Comments on Tech Note 23 Assessments for Yakima County 2015 to 2021

Friends of Toppenish Creek – August 1, 2021

1. This is the WSDA Map that the agencies use for determining Aquifer Susceptibility to pollution from lagoons².

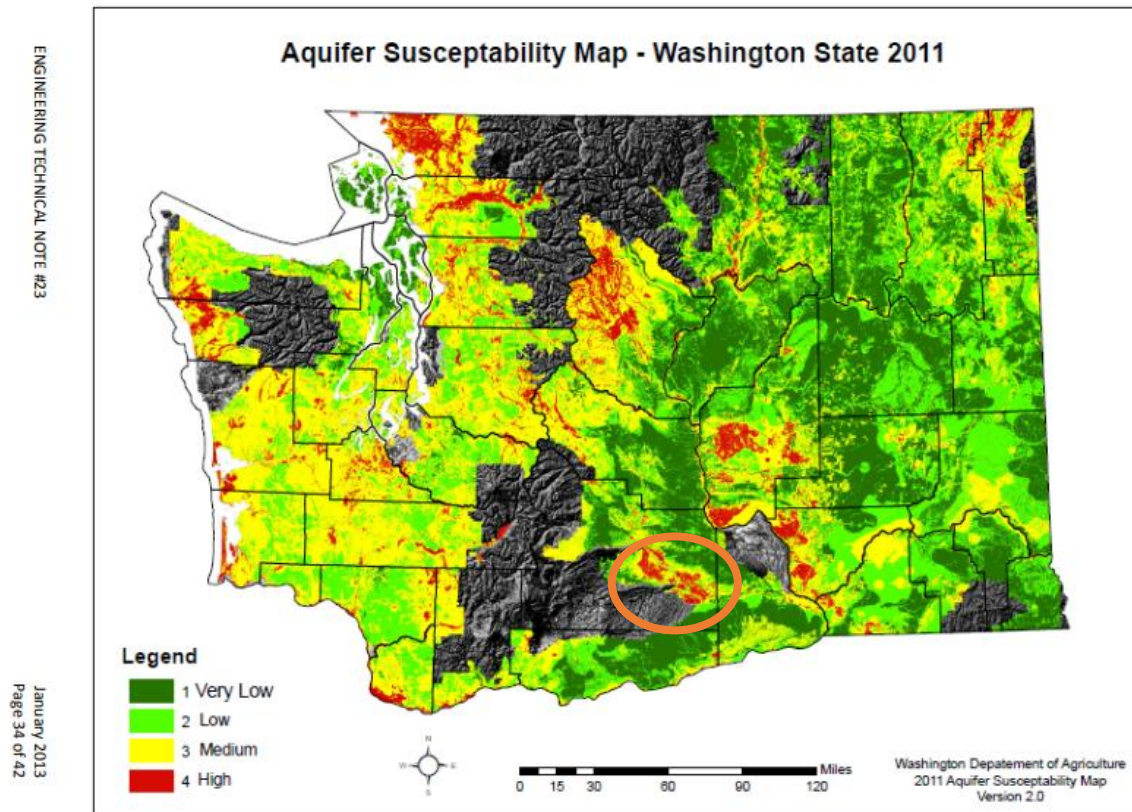
Much of the Lower Yakima Valley falls into the “High” category. But none of the dairies in this study had an aquifer susceptibility score greater than 3 - Medium. (See Columns U & BF) This indicates a tendency to downplay problems associated with manure lagoons.
